5TH & LENORA

Recommendation Meeting #2 Summary **10**

DESIGN REVIEW RECOMMENDATION MEETING #3 - SEPTEMBER 4, 2018

ADDED TOWER TWIST - 1

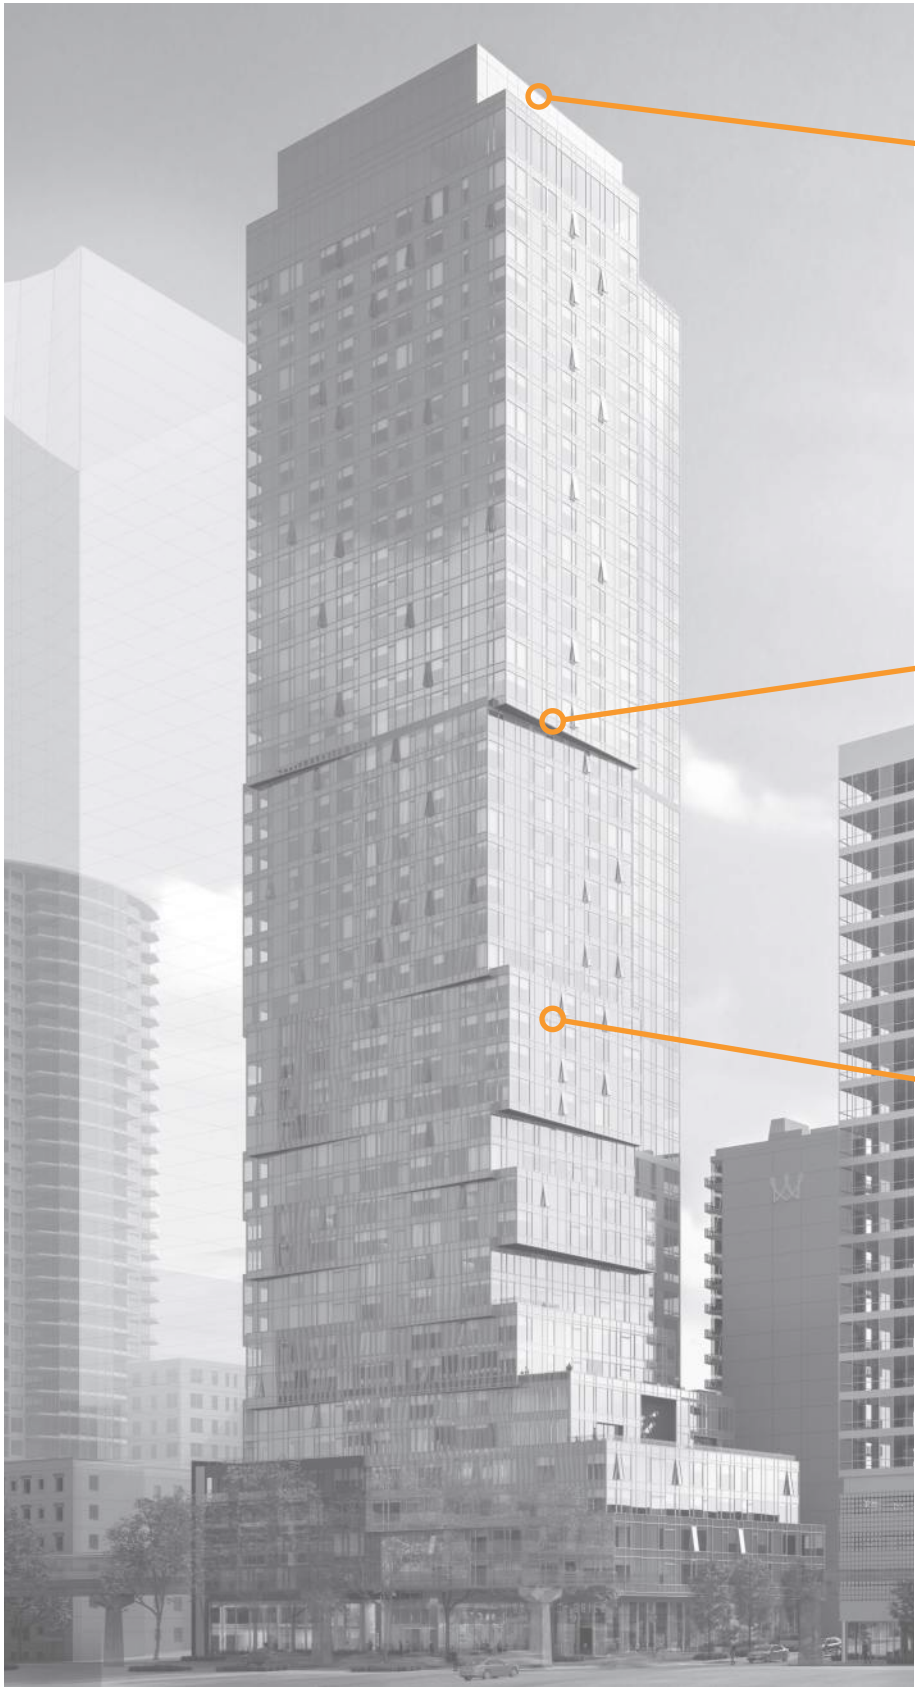
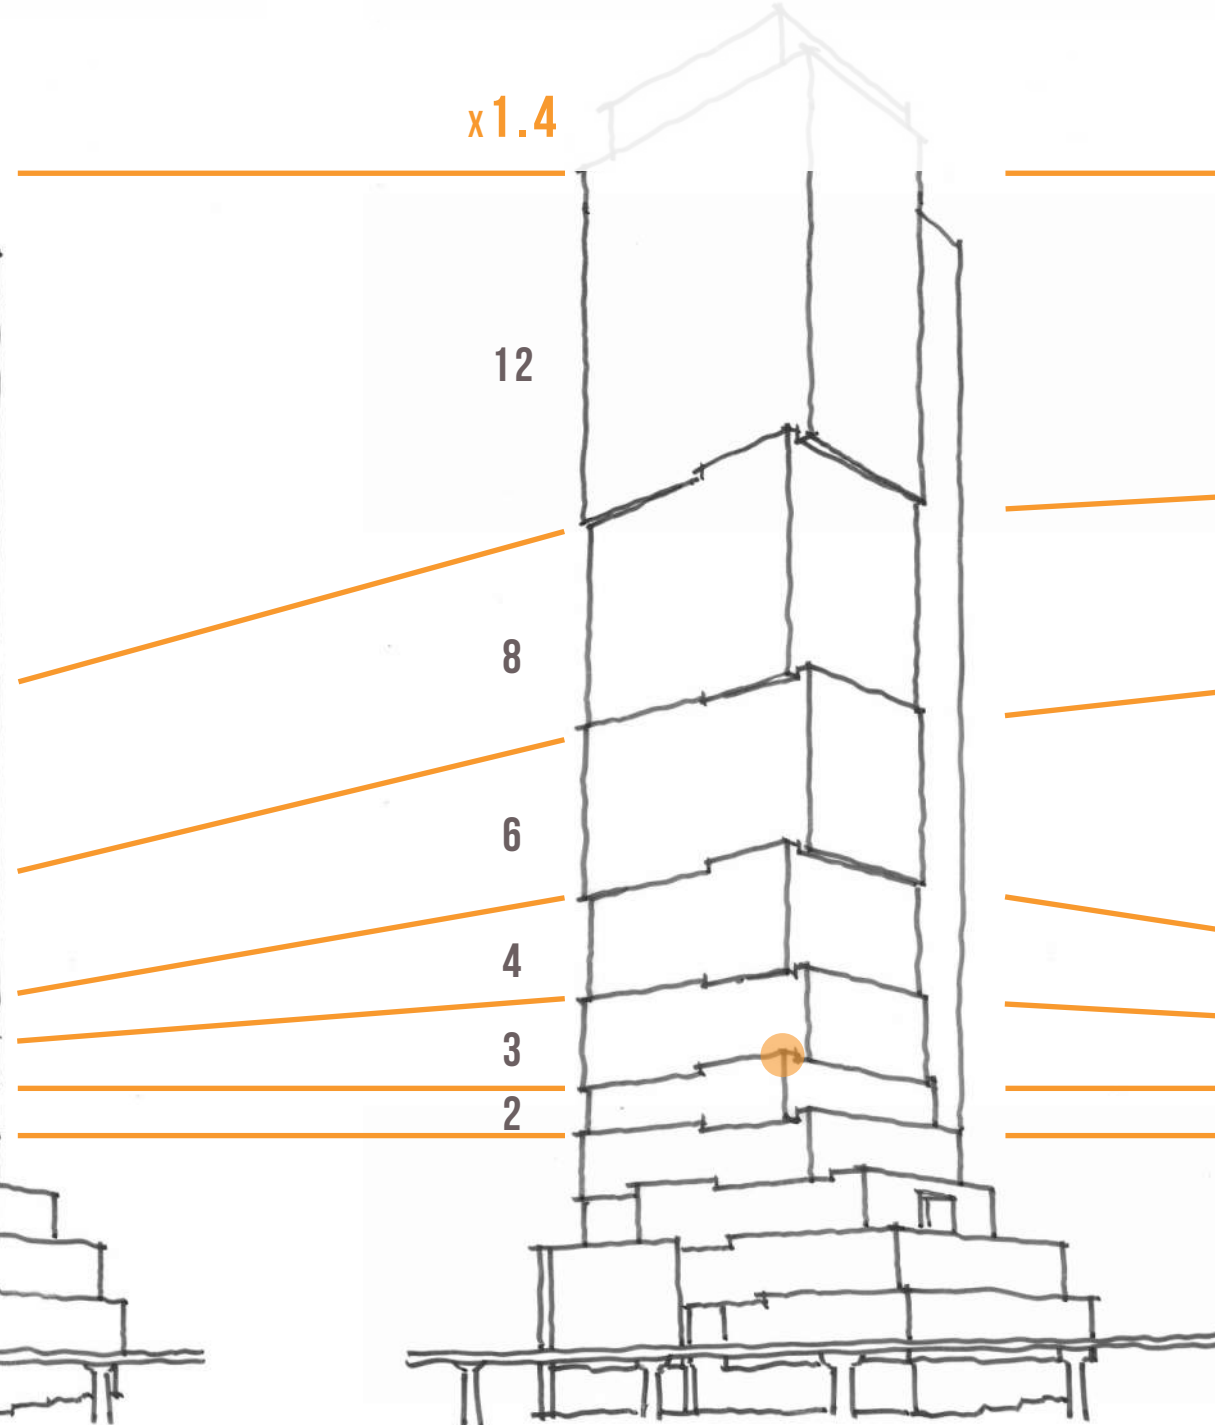
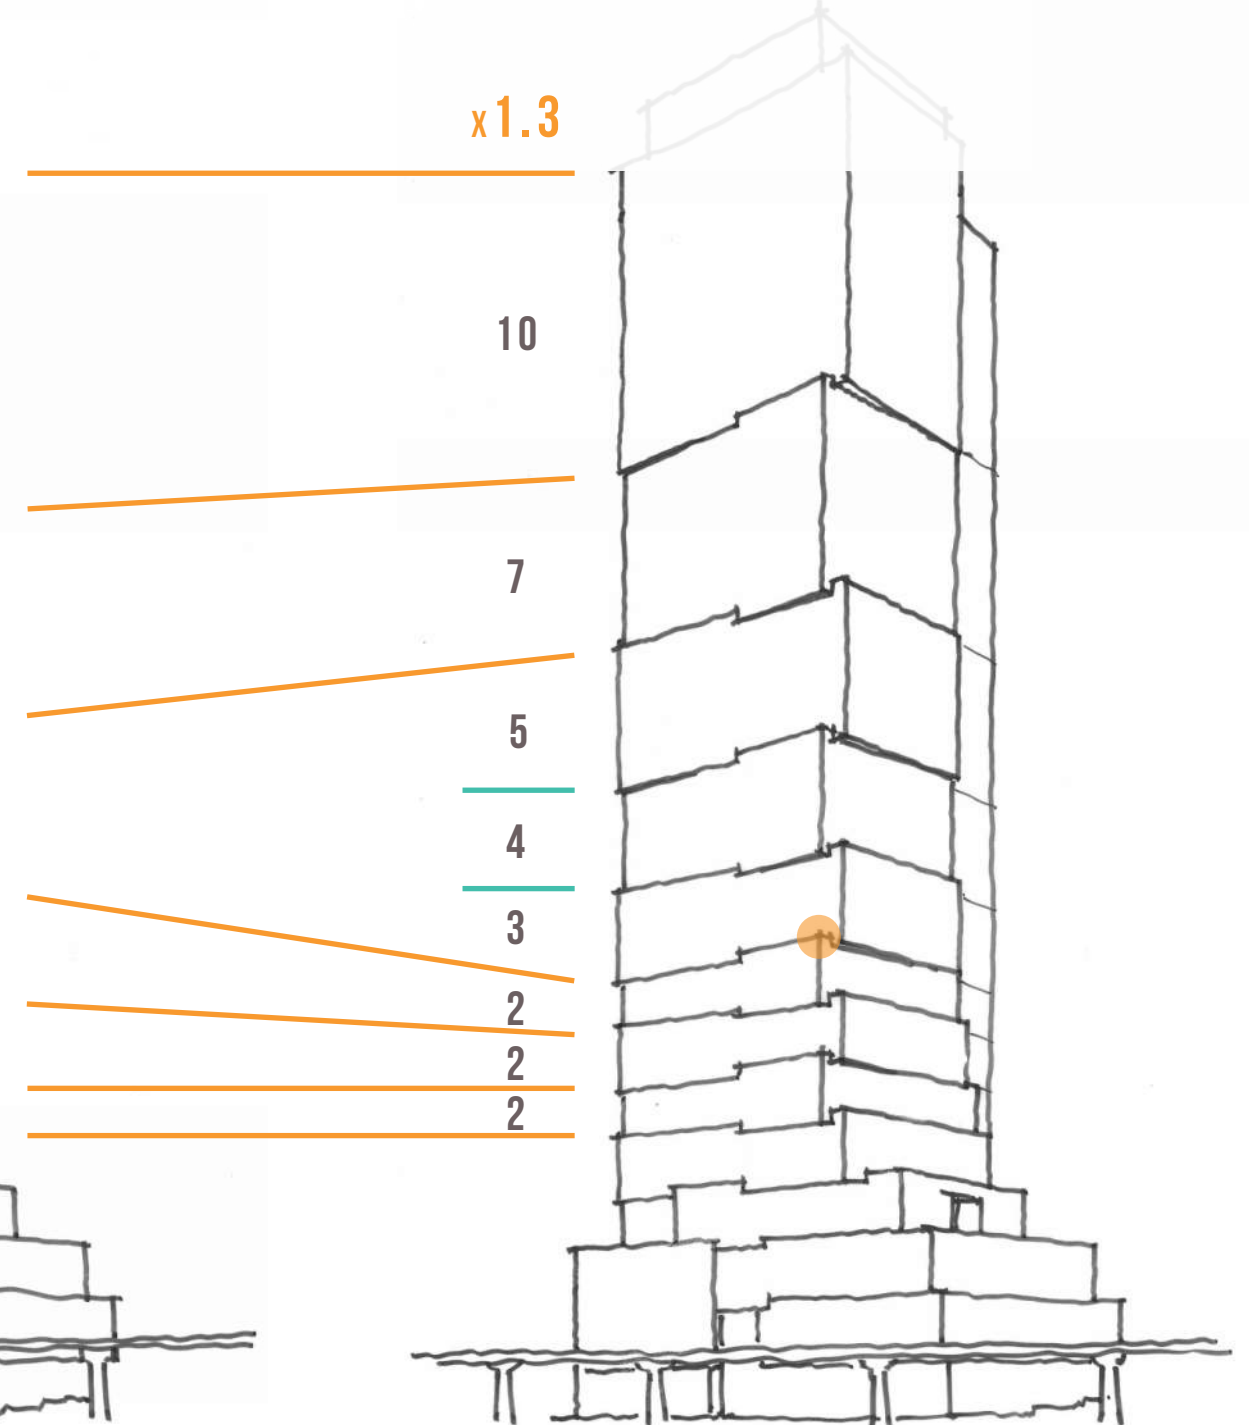
a. The Board discussed the top ½ of the tower form and felt it was too regular, too standard in its blocky form, and didn't fit the building concept presented in the bottom ½ of the building. The upper ½ is too straight too plain, too tall, while the bottom trays (splash zone) was very interesting. The tall “water fall” concept is appreciated, but the Board decided that some relief in the upper straight box form needs to be added. The Board clarified the discussion by noting that at 400 feet the current proposal was fine (with a top, unique, long-view element), but at a higher proposal (such as 400-440 feet) a new twisted tray needs to be added in the “fall” portion. The Board directed the applicant to add the new tray at the best location per the designer’s discretion.(B3.2, B4.1)

Twisted-step massing of the “waterfall” tower element extended to top of building with additional step modulation (addressed under separate guidance)
- B

Twisted-step building modulation locations revised to provide a more proportional, gradual relationship and distribute them throughout the tower height while retaining the desired perspective-foreshortening and scale effects.

ROOFTOP MASSING AND AMENITY

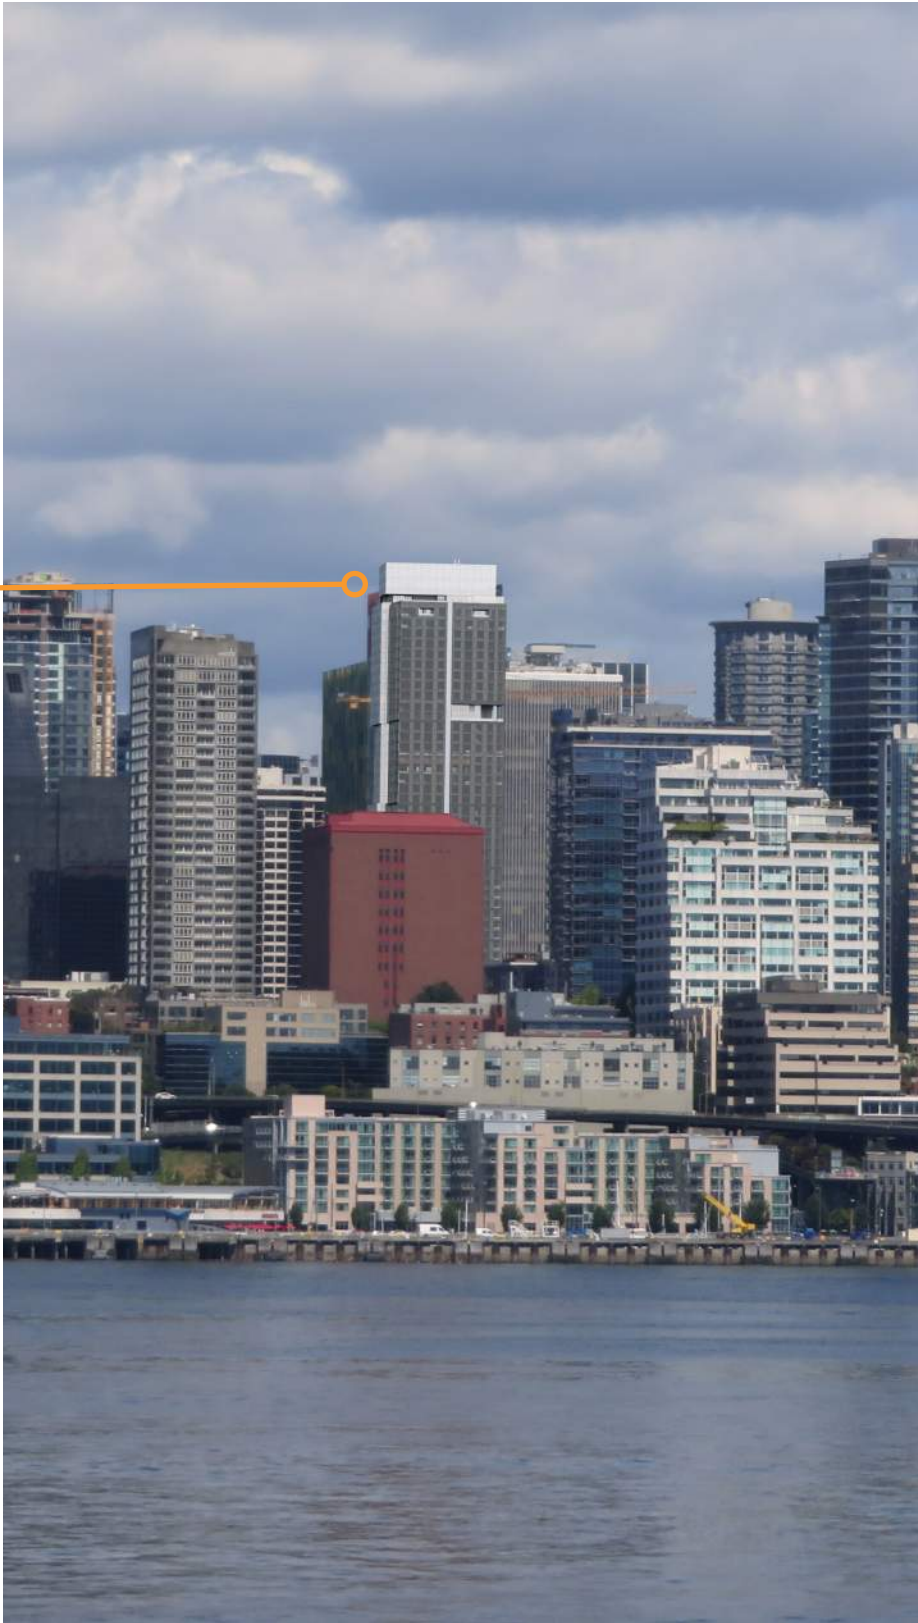
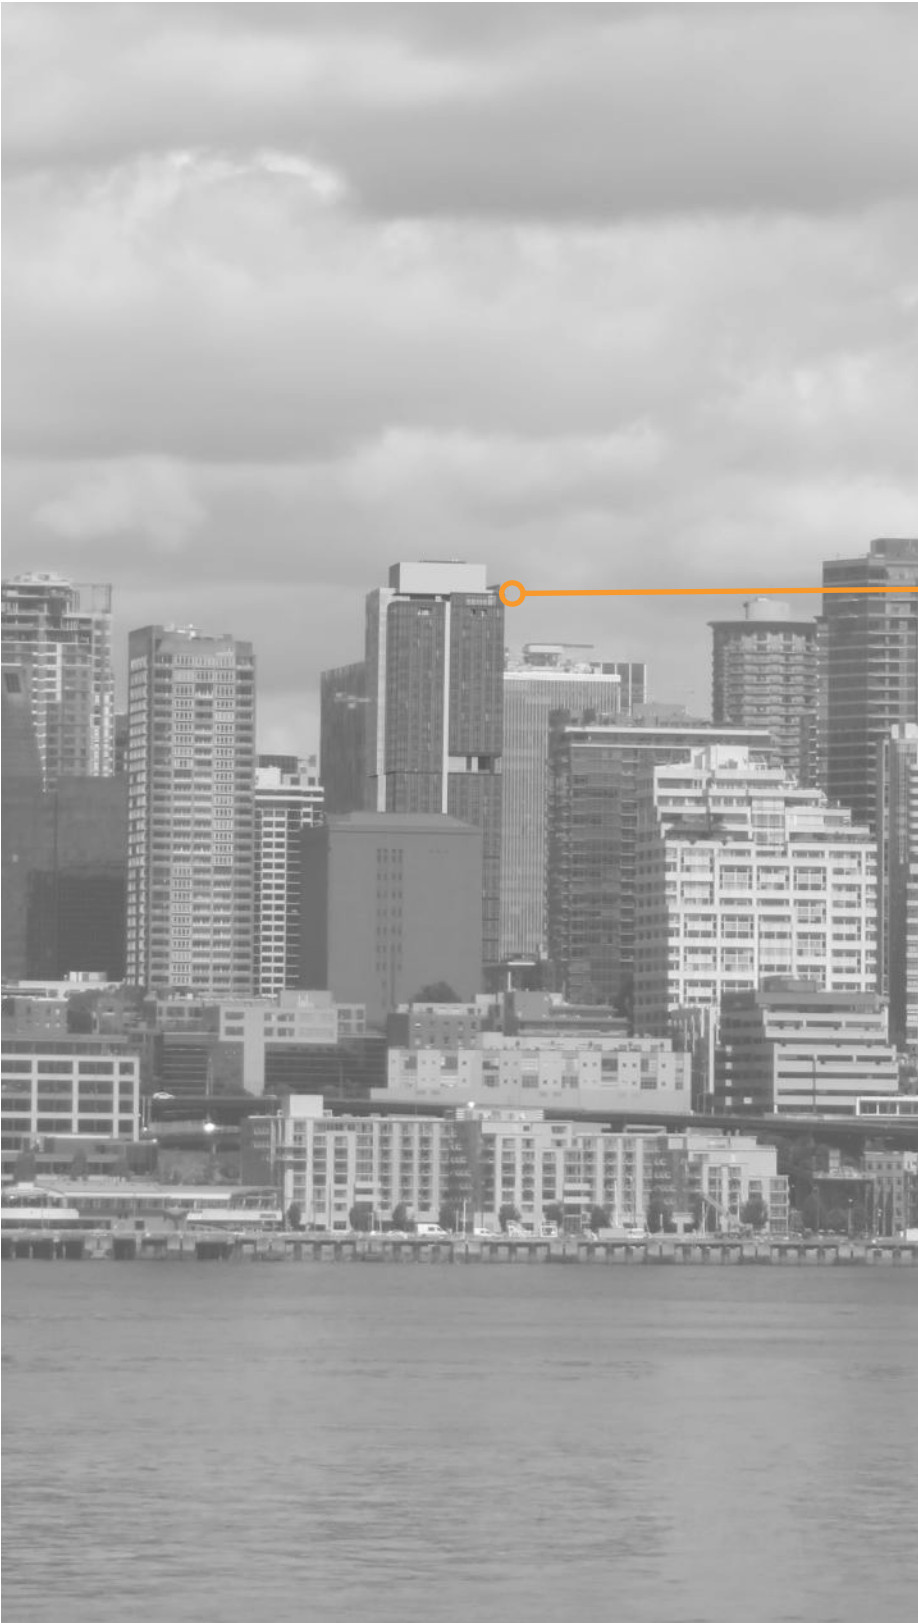
b. The Board felt that there needs to be a unique long-view element at the top of the building to express the building concept and signal the building’s unique design and directed the applicant to design an element to meet this guidance which could happen at the building top or mechanical penthouse design. (A2.1C, A2.2)

Extension of material and massing from “waterfall” tower element to skyline cap expresses tower concept on the skyline from all view angles.
